## Re: Transport Colorado Sub-Area No 2 ISP 2 Response to Third Submission Review Infrastructure Site Plan Application (Submittal #4)

Number: DA-1793-21  
Case Numbers: 2023-6019-00

**Site Plan**

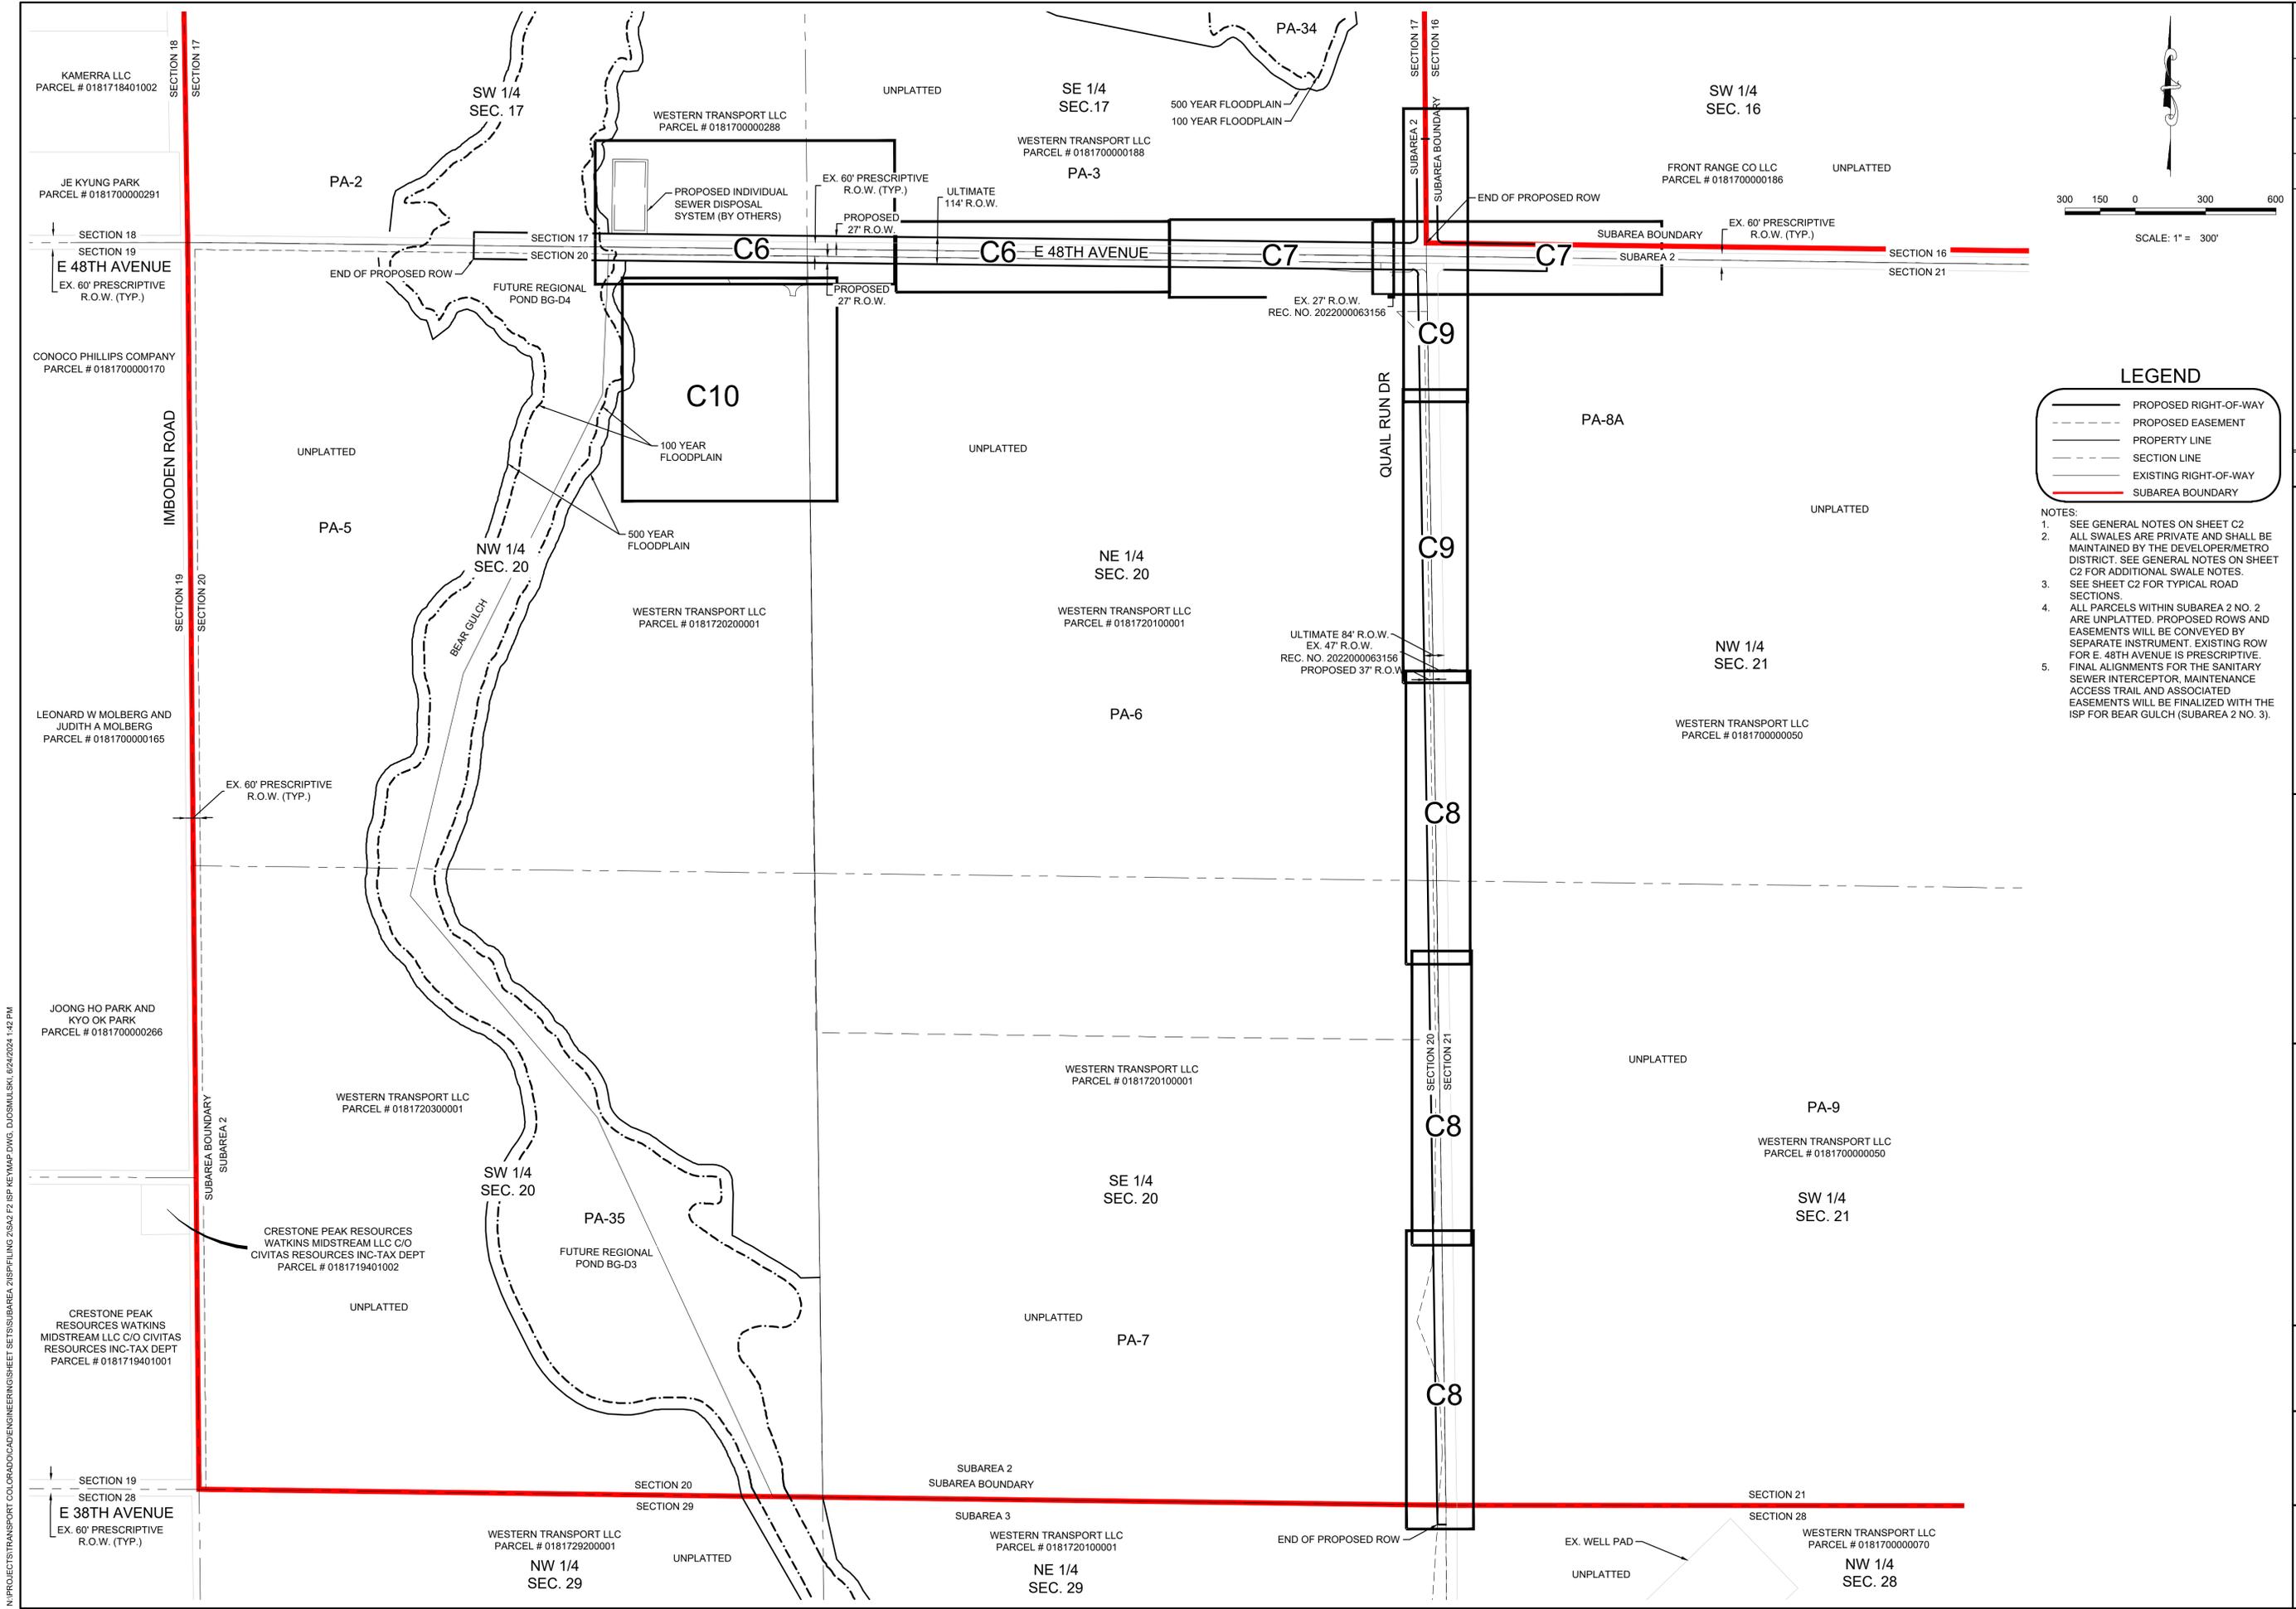
- 7A. Per the updated IWMP2 this can be a 16-inch unless you need a 24-inch to support your development.  
**RE: Acknowledged, water line size to remain 24 inch.**
- 7B. Remove "temporary" from all blow offs. For larger diameter mains, anything over 12-inches, the blow off needs to be 6-inch. Typical for all blowoffs.  
**RE: Blow offs have been adjusted.**
- 7C. Advisory: I want to restate this since it has been a while since these plans have come in. Sanitary sewer mains over 15-inches require CDPHE approval. This will not hold up the ISP but is a requirement of civil plan approval.  
**RE: Acknowledged, we are aware CDPHE permitting will be required.**
- 7D. Adjust manhole to be outside of the 100-year flood plain.  
**RE: Manhole location has been revised**

C11

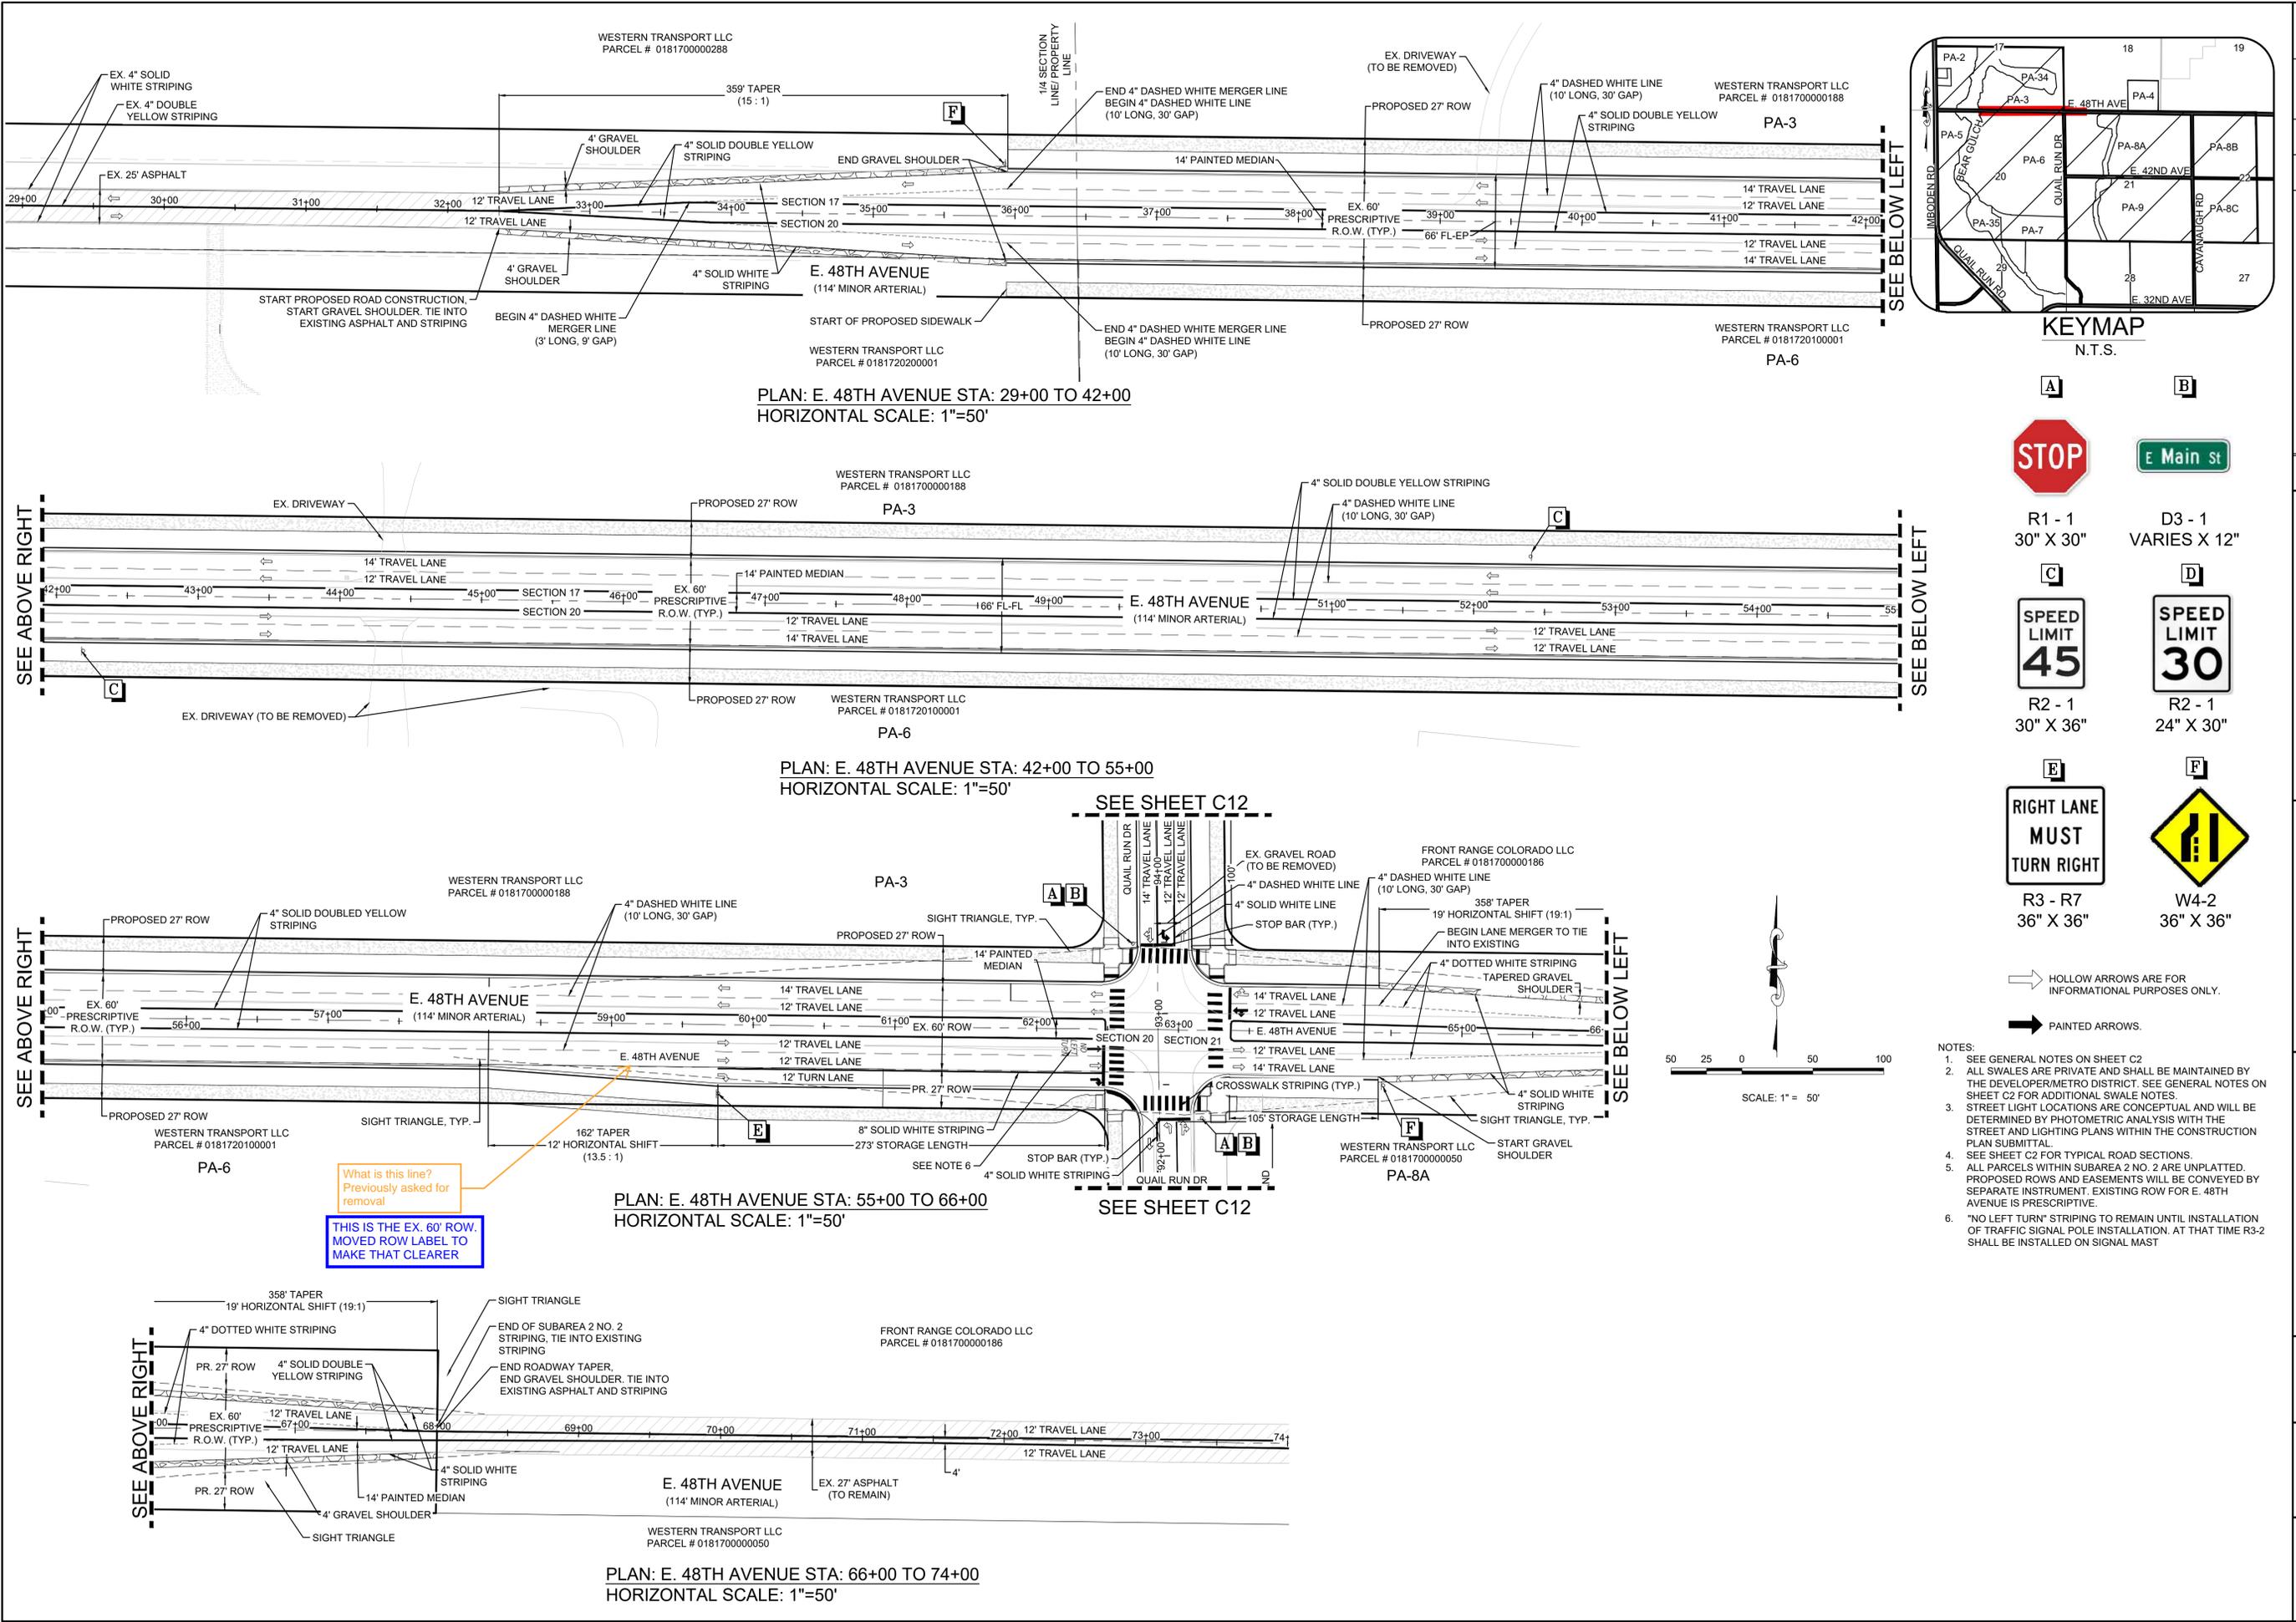
What is this line?  
Previously asked for  
removal

THIS IS THE EX. 60' ROW.  
MOVED ROW LABEL TO  
MAKE THAT CLEARER

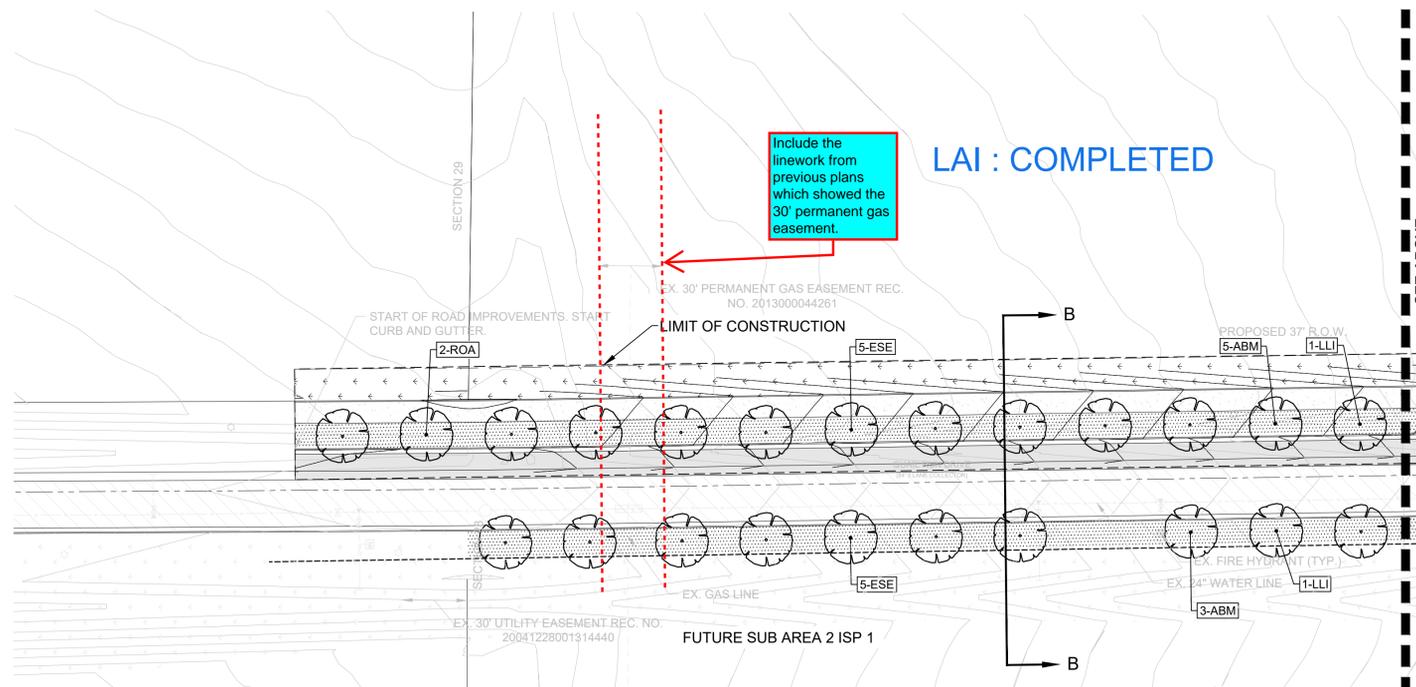
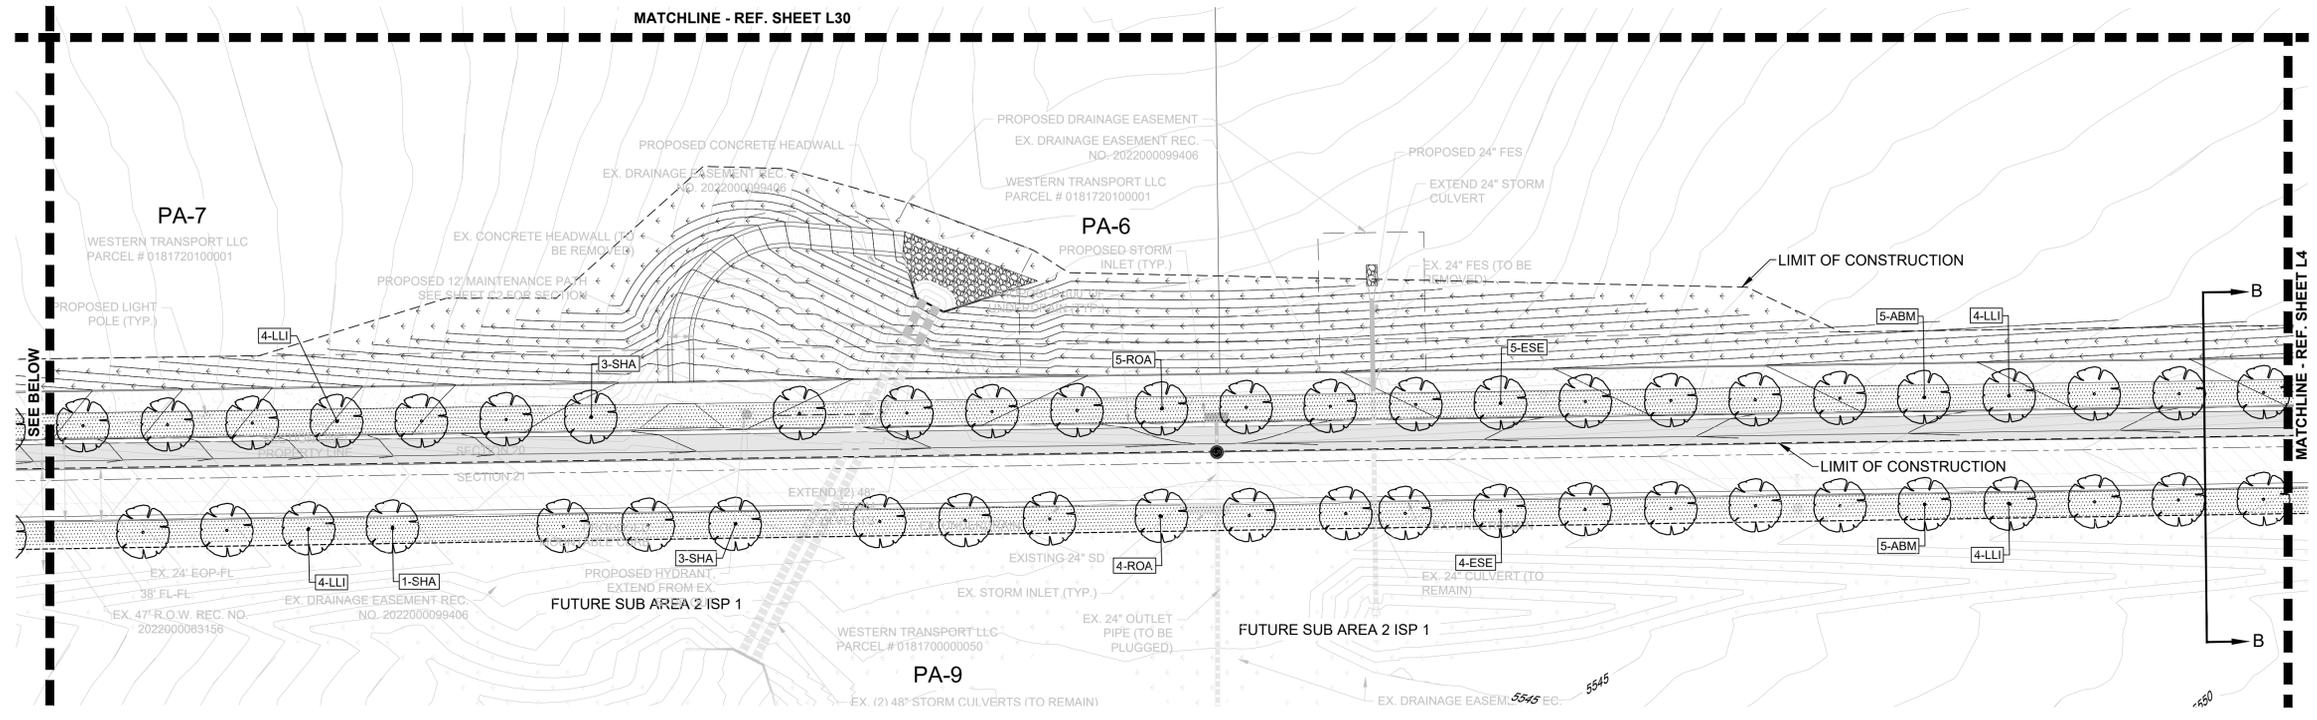
Include the linework from previous plans which showed the 30' permanent gas easement.

LAI : COMPLETED
